# Planning and Development Department

Self-Certification
Per Review Training
Electrical

# **Electrical Peer Review**

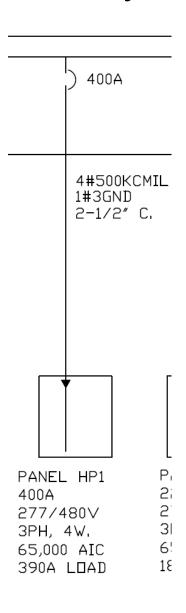
- Neutral conductor required to be run to service disconnect per NEC 250.24(C)
- Main Bonding Jumper required to be located in each service disconnect enclosure. NEC 250.24(B)
- Grounding electrode conductor required to be routed to service disconnect per NEC 250.64(D)
- Disconnect is required to be SUSE rated.

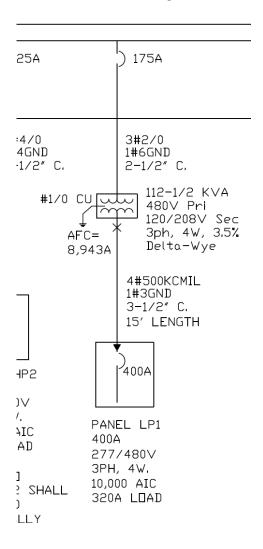
- Feeder conductors are undersized. 380A of conductor capacity vs. 390A load. NEC 310.15(B)(16).
- Feeder conduit is undersized.

- Secondary conductors are undersized. Must be full ampacity based on secondary OCPD, (380A conductor vs. 400A OCPD) NEC 240.21(C).
- Secondary ground wire,
   Supply Side Bonding
   Jumper, is undersized.
   Must be based on the
   derived phase conductors.
   Minimum #1/0 per NEC
   250.30(A)(2) &
   250.102(C).
- Transformer is overloaded.
   312A capacity vs. 320A
   load.
- Panel LP1 voltage incorrect.

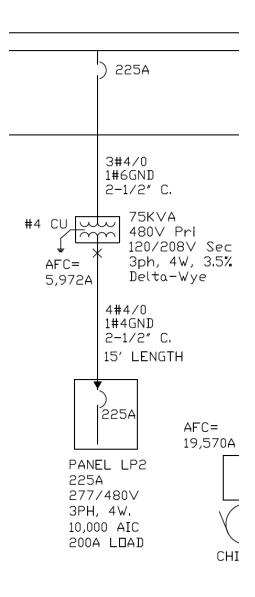
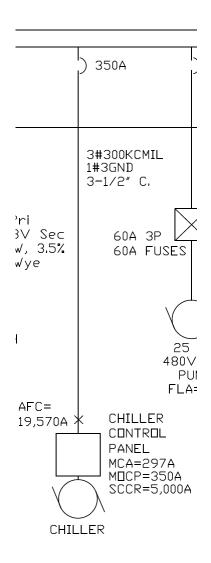
- Grounding electrode conductor to transformer is undersized. Must be minimum #2 per NEC 250.30(A)(5).
- Supply side bonding jumper in secondary feeder is undersized. Must be minimum #2 per NEC 250.30(A)(2).
- Panel LP2 voltage incorrect.

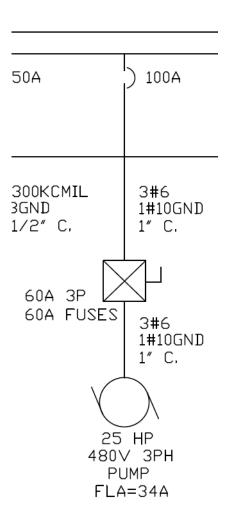
- Chiller control panel SCCR is exceeded by Available Fault Current, AFC.
   (5,000A vs. 19,570A)
   NEC 110.10.
- Feeder conductors are undersized. 285A capacity vs. 297A load. NEC 310.15(B)(16).

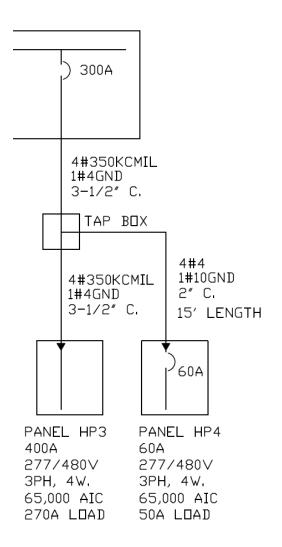
Feeder breaker exceeds maximum size permitted by NEC 430.62. Feeder conductors are not protected.

- Total sum of loads from Panels HP3 and HP4 exceed the feeder conductor rating and the feeder OCPD rating. 320A load vs. 310A conductor and 300A breaker.
- Equipment grounding conductor from tap box to Panel HP4 is undersized.
   Must be based on the feeder OCPD, #4 required per NEC 250.122(G).
- Ungrounded tap conductors from tap box to Panel HP4 are undersized. Tap conductor ampacity is required to be not less than 1/3 the rating of the feeder OCPD per NEC 240.21(B)(2)(1).
